**EuP TREN Lot 1 – Ecodesign requirements for boilers
Calculation method and testing
Comments in follow-up of meeting on 16 December 2009**

EuP - TREN Lot 1 - Calculation method & testing
Comments in follow up of meeting on 16th December 2009.

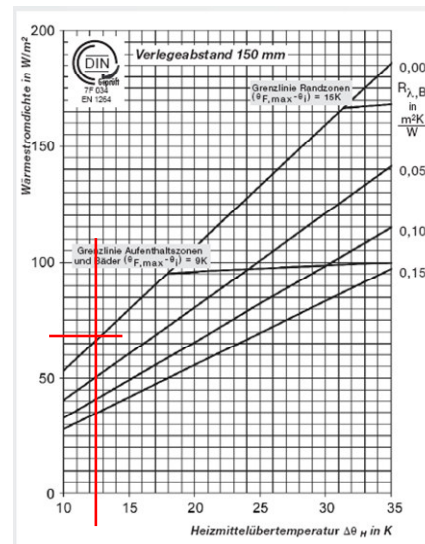
1.3. For floorheating, typical system temperatures do not exceed 35°C leaving water, and are limited to 32,5°C (Flow 35°C/Return 30°C) in the model. The present calculation does not take this into account. (reference to EN 14511, Ecolabel, NFPAC, EHPA label, UK MCS (-Rating point for UFH applications = 35°C flow /30°C return))

EN 1264 specifies very clearly that the following temperatures may not be exceeded for physiological reasons:

comfortzones: 29°C

borders (sides): 35°C

bathrooms: 33°C

Heat emission of underfloor heating in function of Tsys is not correctly described by radiator formula with n=1,3. Practically, a more linear relation is valid. (see example of EN 1264 certified underfloor heating system)

> EPEE proposes as follows:

Maintain the calculation of T_{sys} with radiator formula, but

- adapt exponent n to 1,0 for linearity and
- Pradnom for UFH in average and warm climate to 3,6 and for cold climate to 4,3

to achieve T_{sys} of 32,5° at design T_a .

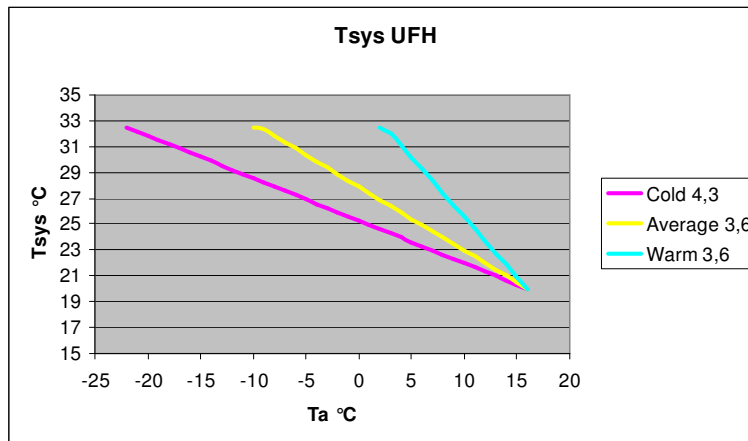
This means that present formula

$20+50*(P_{sysA_tp}/PradnomA)^{(1/1,3)}$	changes to	$20+50*(P_{sysA_tp}/PradnomA)$
---	------------	---------------------------------

As a result, the following system temperatures will be achieved. These temperatures reflect the actual situation.

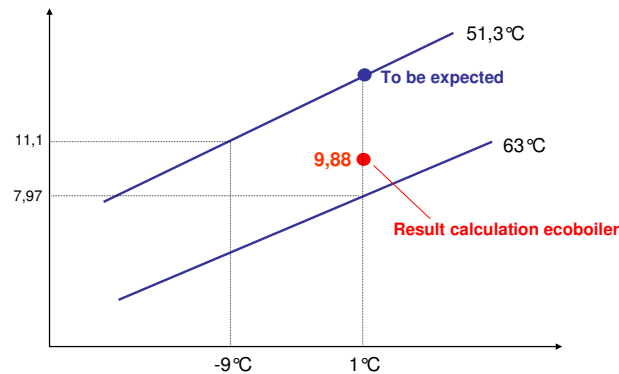
- 2.2. There seems to be an anomaly for determining capacity and COP at setback condition:
When the system temperature at night is changed to the system temperatures of any condition in the BIN, it is not possible to find the similar capacity, which should be a logical result. It is unclear, however, how to correct this.

Ta	Tsys	Phpmax	COP
Night	1°C	63°C	7,97kW	1,88
	-9°C	51,3°C	11,1kW	1,88
Night convert Tsys to Tsys of -9°C	1°C	51,3°C	9,88kW	2,3

> EPEE feels that the proposal of Mr Kemna to abandon this conversion is acceptable, but feels that the benefit on efficiency should be granted as being between 3-6% instead of 2-3%
